AIRCRAFT

SUBJECT: Replacement or inspection of distributor gears in D-3200 Series pressurized (blue) magnetos

Figure 1. Location of "x" on Identification Plate

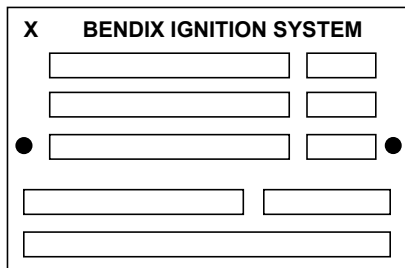
1. All subject magnetos with over 100 operating hours must have the distributor gears replaced or inspected prior to further flight, unless the magneto is identified by the letter "x" in the upper left corner of the identification plate (see figure 1). The "x" on the identification plate indicates previous compliance with this Service Bulletin.

5. Reassemble the distributor block with new serviceable gears and reassemble the magneto.
6. After installing new serviceable gears, identify the magneto by stamping the letter "x" in the upper left corner of the identification plate, before the word "Bendix" (see figure 1).

Figure 2. Checking for Loose Electrode

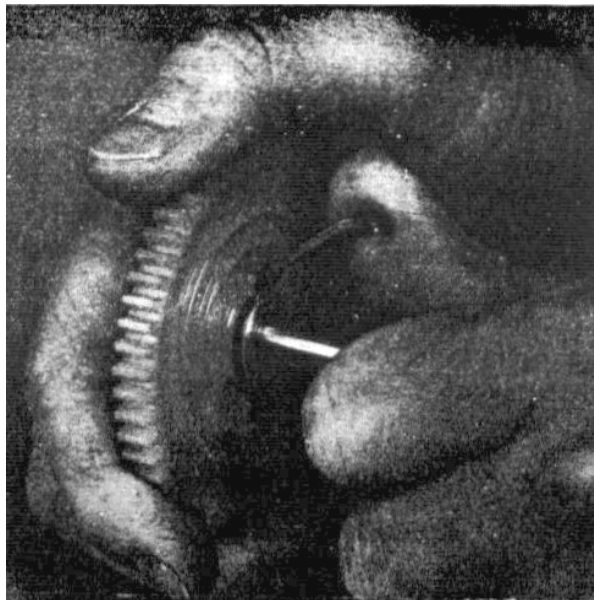
9. Inspect each gear for a loose electrode by grasping the gear firmly in one hand and alternately exerting clockwise and counterclockwise force against the electrode with maximum hand pressure. This should be done in a manner that would attempt to pivot the electrode around the axle (see figure 2). If any movement between the electrode and gear is detected, the gear must be discarded and replaced with a serviceable gear.
